Change Order

PROJECT (Name and address):
Radcliff Elementary School Renovation
- Phase 3
1145 S. Dixie Boulevard
Radcliff, Kentucky 40160

CHANGE ORDER NUMBER: 004
DATE: April 27, 2011

Project Name: Radcliff Elementary
AEI Project Number: 211-059
Date: 3/28/11
Contractor: Morel

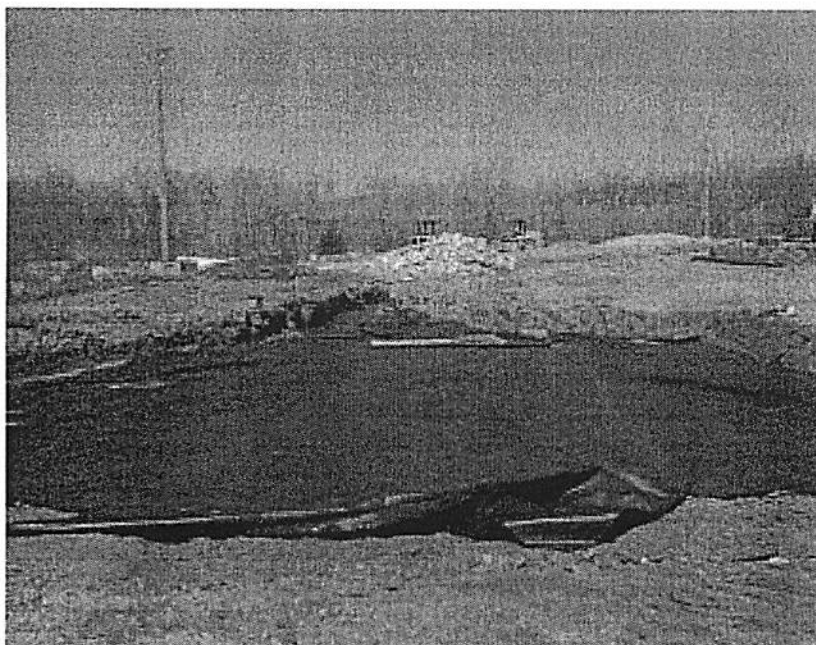
AEI was on site to observe undercutting of areas that failed proofrolling the previous week. The area was undercut an average of 24" with the contractor cutting one area slightly deeper in an effort to drain any moisture that may become trapped in rubberized concrete. This area can be seen in photo documentation. After the areas were undercut geotextile fabric was placed prior to stabilizing. Larger pieces of material were brought in for the first lift and were capped off with finer material prior to rolling with a tamping foot. An additional area not previously proofrolled showed evidence of pumping and rutting where the new pavement was connecting to the existing pavement. The same undercut was recommended for this area. It was then repaired in the same manner as other unsuitable areas. The approximate undercut was 55 cubic yards prior to fabric and fill placement.

Large area of parking that failed proofroll being undercut.

Geotextile fabric was placed prior to fill with drainage ditch near curb box.

Larger material being placed in first lift.

Additional undercut area connecting to existing pavement.

Project Name: Radcliff Elementary
AEI Project Number: 211-059
Date: 3/18/11
Contractor: Morel

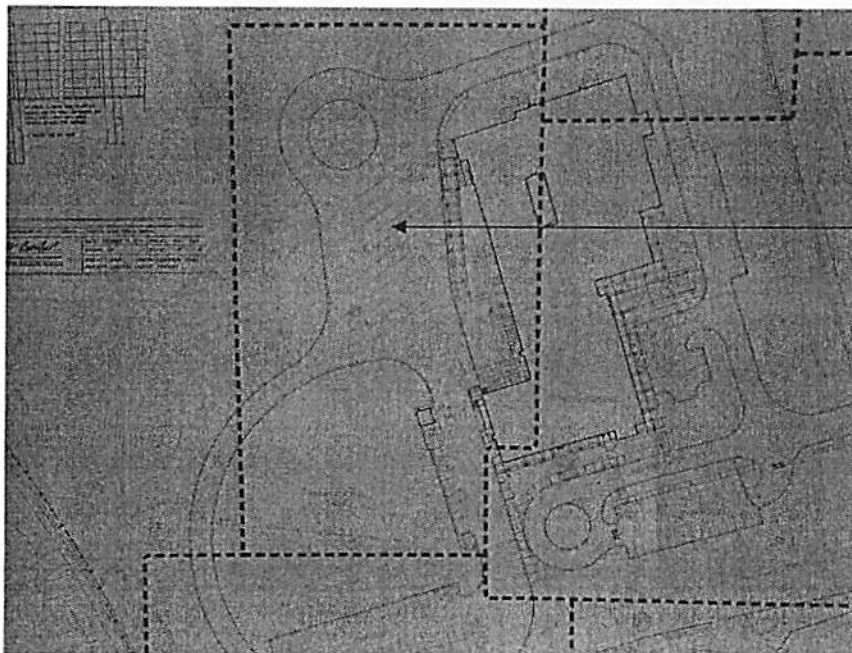
AEI was on site to observe a proofroll on all areas behind the existing school where fill was placed. All areas were proofrolled with little or no evidence of deflection with the exception of the area noted below. Approximately 3500 square feet of questionable soils were marked and it was recommended to the contractor to undercut these areas 18"-24" and backfill with rubbleized concrete. An additional proofroll is to be performed after the areas have been undercut and backfilled. No further proofrolling will be required for the road around the existing baseball field.

Area that proofroll
showed areas of
pumping and rutting.

Parking area showing evidence of pumping and rutting.

Transition from parking area to road around baseball field showing rutting.
